SPIRE-RAL-COM-0001480  
From: Doug Griffin  
To: Gary Parks  
CC: John Delderfield, Bruce Swinyard, Eric Sawyer  
Date: Tuesday, 07 January 2003  
Issue: 0.1

As promised last week, please find below a detailed list of the issues with the JPL documentation that we have found. Some of these issues were detected after the Dec. 2002 Saclay meeting.

A1 10209722

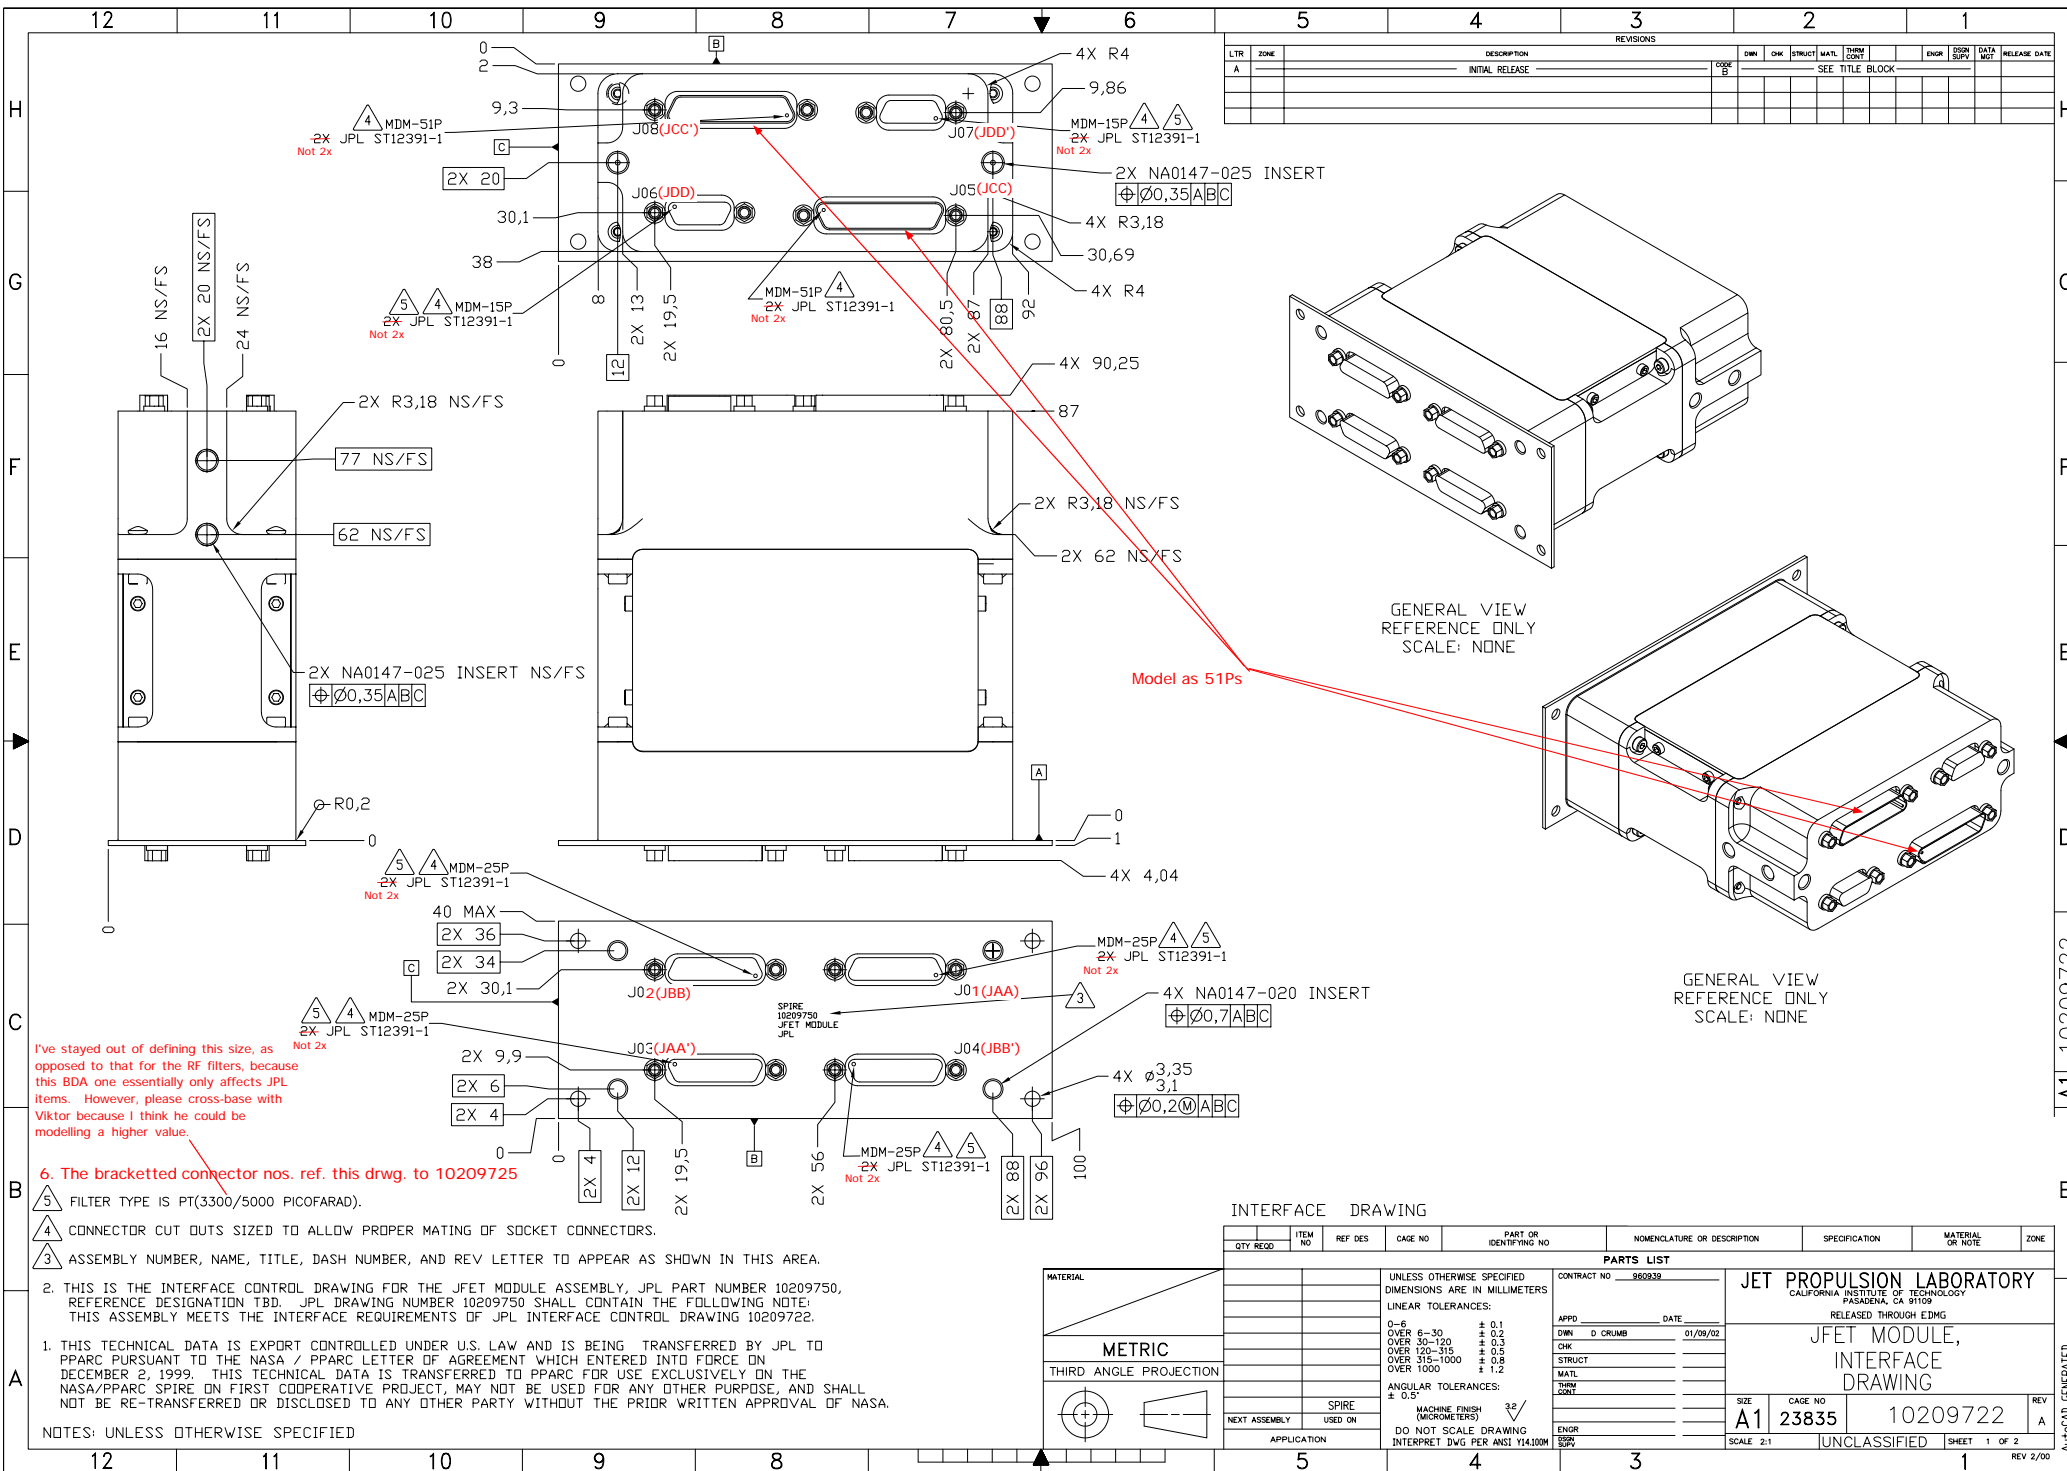
3	10209721-A	Sheet 7, Grid G11	<ul style="list-style-type: none"> <li>• Reference: Comment 1</li> <li>• SLW Should be: J05 (John Coker has signed this issue, I understand that it is OK from a mechanical point of view to move it from J01 but MSSL need to sign off on this)</li> </ul>	
4	10209722-A Prerelease 6	Sheet 1, Grid D2, H8, G7	<ul style="list-style-type: none"> <li>• View of 51-Way MDM connectors (J05 and J08) shown at D2 as Sockets; should be Pins</li> <li>• View of 51-Way MDM Connectors (J05, J08) are drawn as sockets (double line around the “D” profile instead of a single line); should be Pins</li> <li>• See “JD Annotated 10209722.pdf”</li> </ul>	
5	10209722-A Prerelease 6	Sheet 1, Various Grid	<ul style="list-style-type: none"> <li>• To have agreement in nomenclature between 10209722 and 10209725, the connector labels should be changed on 10209722 as follows:</li> </ul>

Comment Number	Drawing number and issue	Sheet # / Grid reference	RAL Comment	Closure
			<ul style="list-style-type: none"> <li>o J01 -&gt; J02 (JBB) (Grid C9)</li> <li>o J02 -&gt; J01 (JAA) (Grid C7)</li> <li>o J03 -&gt; J03 (JAA') (Grid C9)</li> <li>o J04-&gt; J04 (JBB') (Grid C7)</li> <li>o J05 -&gt; J05 (JCC) (Grid G7)</li> <li>o J06 -&gt; J06 (JDD) (Grid G9)</li> <li>o J07 -&gt; J07 (JDD') (Grid H7)</li> <li>o J08 – J08 (JCC') (Grid H9)</li> <li>• See “JD Annotated 10209722.pdf”</li> <li>• Note: Both John and I agree that it would in fact be better if the labels J01 through J08 were removed from the drawing and replaced simply with JAA, JBB, JAA', JBB' etc. as it has been agreed that the units will be supplied without J numbers inscribed next to the connectors. The Jxx labels will be added by RAL after JPL delivery.</li> </ul>	
6	10209722-A Prerelease 6	Sheet 1, Various Grid	All connectors labelled as being x2 (i.e. Two off). This is incorrect. They are all one off.

7	10209722-A Prerelease 6	Sheet 2, Various Grid	<ul style="list-style-type: none"> <li>• J01 should be signals A-L</li> <li>• J02 should be signals M-Z</li> <li>• J03, J04 and J08 should be suffixed with an apostrophe</li> <li>• See “JD Annotated 10209722.pdf”</li> </ul>

I've stayed out of defining this size, as opposed to that for the RF filters, because this BDA one essentially only affects JPL items. However, please cross-base with Viktor because I think he could be modelling a higher value.

6. The bracketted connector nos. ref. this drwg. to 10209725
